DART AEROSPACE LTD		Work Order:	164438
Description: Gusset		Part Number:	D3016-17
Inspection Dwg: D3016 Rev: A			Page 1 of 1

DESIGN <i>CP</i>	DRAWN BY <i>CP</i>	DART AEROSPACE LTD HAWKESBURY, ONTARIO, CANADA	
CHECKED <i>#</i>	APPROVED <i>#</i>	DRAWING NO. D3016	REV. A SHEET 1 OF 3
DATE 01.05.18		TITLE SEAT FRAME ASSEMBLY	SCALE NTS
A	01.05.18	NEW ISSUE

DRAWING NO. D3016	TITLE SEAT FRAME ASSEMBLY	REV. A	DART AEROSPACE LTD ENGINEERING ORDER	D.E.O. NO. D3016-A-1	SHEET NO. SHEET 1 OF 1	SCALE NTS
DRAWN <i>1</i>	CHECKED <i>UP</i>	MFG. APPR. <i>RE</i>	APPROVED <i>MP</i>	DE APPR. <i>TH</i>		
DATE 10.01.29	DATE 10.01.29	DATE 10.01.29	DATE 10.01.29	DATE 10.01.29

TO REVISE D3016-11 SADDLE'S HOLE SIZES

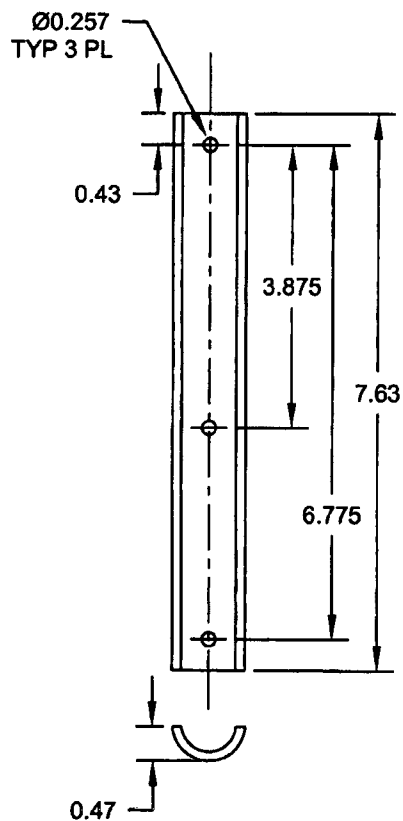
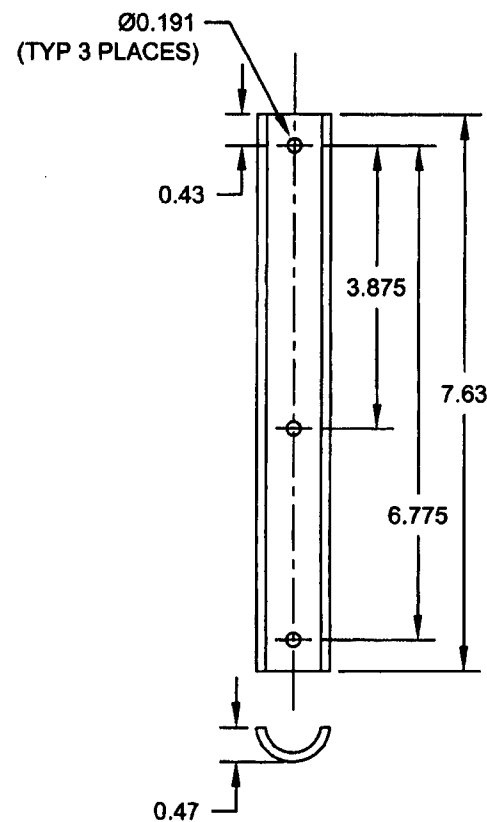
DETAIL D3016-11 SADDLE (SHEET 3): Ø0.257 TYP 3 PL WAS Ø0.191 (TYP 3 PLACES) AS SHOWN:
